Remarks

A. <u>Drawings objected to under 37 CFR 1.83(a)</u>.

UNIQQA-PPA2 S/N 09/902.986 SHT 12 OF 21

FIG. - 13A

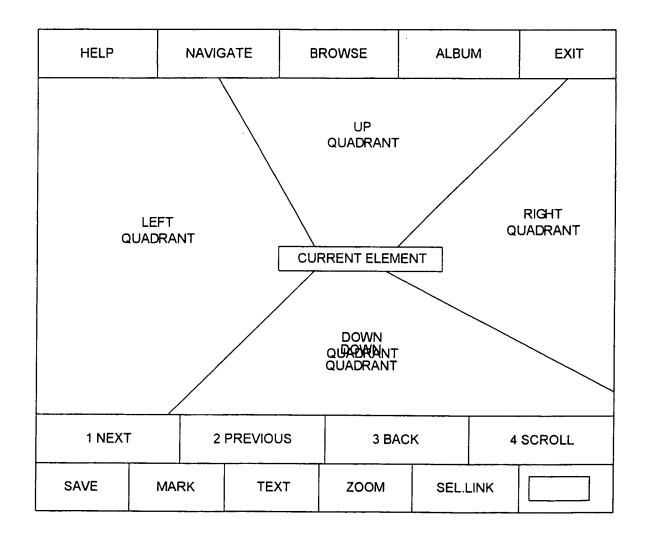
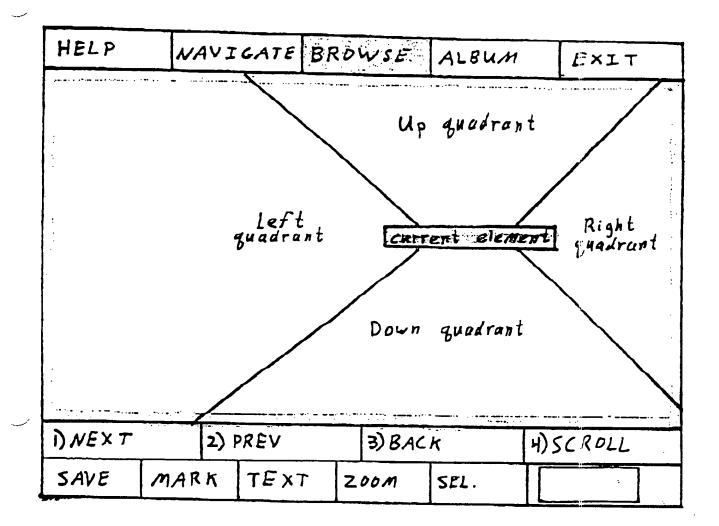
Drawing figures 13A, 13B, 16 and 21 are objected to as failing to show the text labels as described in the specification.

Marked up copy of the amended paragraph beginning at page 21, line 25 (corresponding to the amendments to FIG. 13A).

These drawing figures have been revised to correct the errors noted by the examiner. Where necessary the corresponding specification is amended. No new matter has been added.

Third (step S3), four separate lists of elements are created from the complete list (the primary list) of elements. The display 1300 is divided into quadrants (sub-areas), as shown in Fig. 13(a): LEFT quadrant 1302; RIGHT quadrant 1304; UP quadrant 1306; and DOWN quadrant 1308. Each quadrant is associated with one of the direction keys, and a separate list is created for each quadrant. Elements are copied from the primary list onto the list for a quadrant as long as any part of that element overlaps with the quadrant corresponding to the list. Some elements may be listed in multiple lists. A list corresponding to a quadrant may also be empty when this process is complete, which means that the user has reached the edge of the display region and the direction key corresponding to the quadrant will have no effect.

FIG. - 16

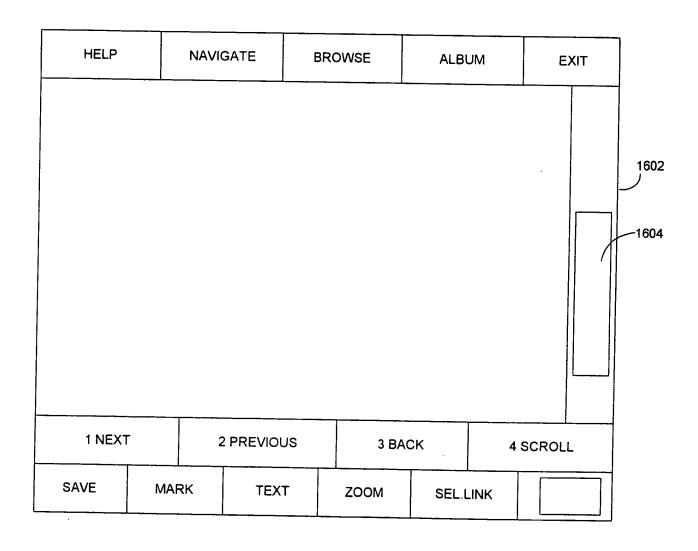
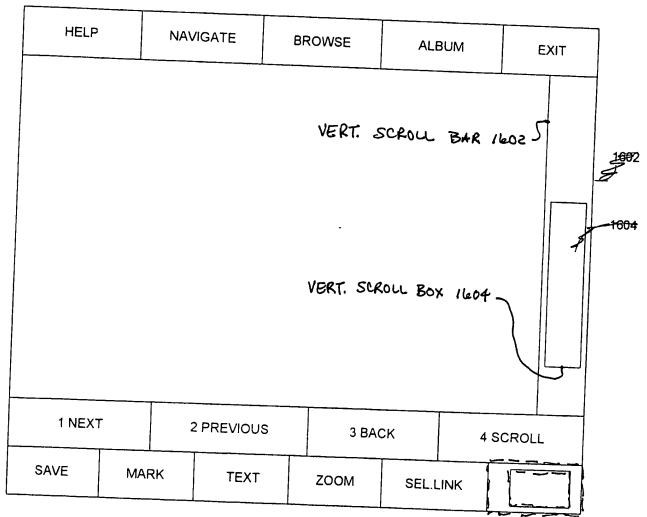
Marked up copy of the amended paragraph beginning at page 26, line 25 (corresponding to the amendments to FIG. 16).

The Scroll command allows the user to scroll the contents of the current display region explicitly, rather than implicitly by navigating the currently-selected page element beyond the borders of the display region. When the Scroll command is invoked, the horizontal and/or vertical scroll bars that are active are redrawn with the selection color, and other selection-color items are "grayed" to represent that the input focus has been transferred to the scroll bars themselves. A scroll bar is "active" when the page data exceeds the size of the display region in the dimension corresponding to the scroll bar. If neither the horizontal nor vertical scroll bar are active, then this command is grayed-out and unavailable (Fig. 16, element 1606). When input focus is in the scroll bars, see Fig. 16, elements 1602 and 1604, the direction keys cause the contents of the current display region to be scrolled in the appropriate direction, and the Select, Star and/or Pound keys end scroll mode and return the input focus to their previous state. The numeric keys are ignored.

FIG. - 21

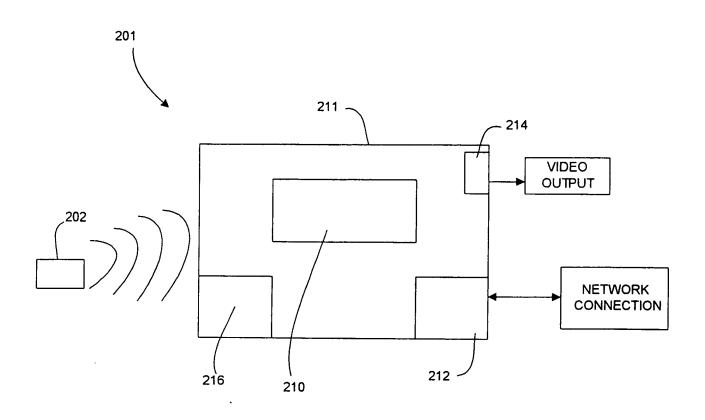
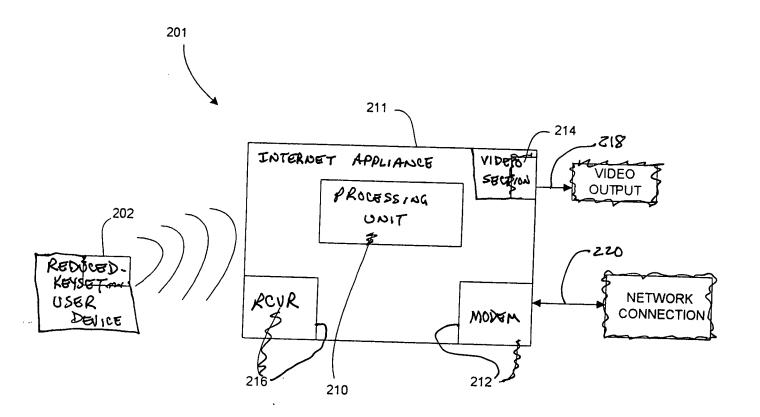
Marked up copy of the amended paragraph beginning at page 5, line 6 (corresponding to the amendments to FIG. 21).

Fig. 21 shows an Internet appliance in which a web browser according to embodiments of the present invention may be implemented. An Internet appliance 201 is a small device that includes a processing unit 210; a wired or wireless network connection device 212 such as a modem for communication 220 with a network; a video section 214 including a video signal output 218, such as a television interface for outputting video and audio signals, or separate video and audio signal outputs; and a user interface signal receiver 216 for receiving user interface signals generated by a reduced-keyset user interface device 202, such as a consumer-type remote control unit. The above components are preferably contained in a housing 211 or provided on the outside surface of the housing to form an integral unit. The processing unit is connected to the network connection device 212, the video section 214 and the user interface signal receiver 216 and controls all functions of the Internet appliance. The reduced-keyset user interface device is a device that has a small number of keys and transmits a small number of keystroke signals associated with the keys. As used in this specification, the term "reduced-keyset user interface device" does not include a device that has a full text-entry keyboard. The video section 214 can be connected to a display such as a television for displaying information, and the Internet appliance unit does not have its own video display or other graphic display devices. The user interface signal receiver 216 is the only device for receiving user interface information from the user (via the reduced-keyset user interface device 202), and the Internet appliance unit does not have its own keyboard input device with text-entry keys. The lack of an integral video display device and a keyboard allows
